Briefing note- additional information in relation to RN: 2015/3605/P

Introduction

This note provides further information in relation to representations made during the consultation period of this application. Each heading is considered in turn with comments we are responding to summarised with a response from the consultant team.

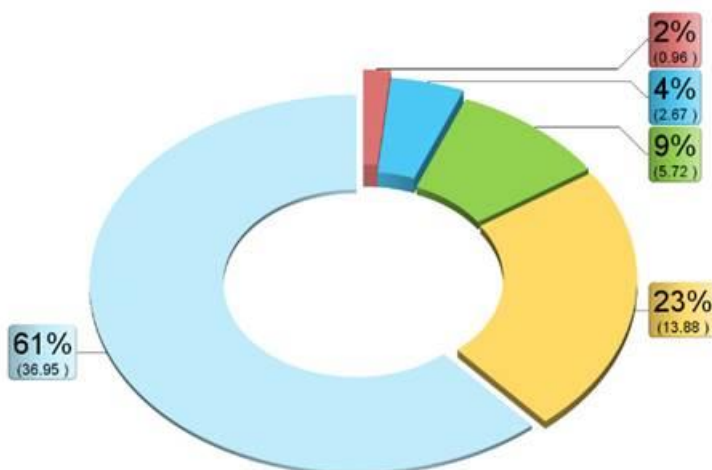
- **Item 2: 'As requested during pre-app correspondence, regulated and unregulated energy demands in kWh/yr (broken down into use type – heating, hot water etc) and associated CO2 emissions should be stated at each stage of the energy hierarchy. Outputs of the ASHP (kWh/yr) and energy required to operate the heat pump should also be made clear'.**

Response: Below are the calculations broken down into individual elements as requested from the Part L2A modelling assessment of the Energy Statement and BREEAM Pre Assessment:

Annual energy (Be Lean + ASHP):

Heating	=	0.96kWh/m ²
Domestic Hot Water	=	36.95kWh/m ²
Cooling	=	2.67kWh/m ²
Aux	=	5.72kWh/m ²
Lighting	=	13.88kWh/m ²

■ Heat ■ Cool ■ Aux ■ Lights ■ DHW

DHW	=	61% of annual energy
Lighting	=	23%
Auxiliary (fans / pumps)	=	9%
Cooling	=	4%
Heating	=	2%
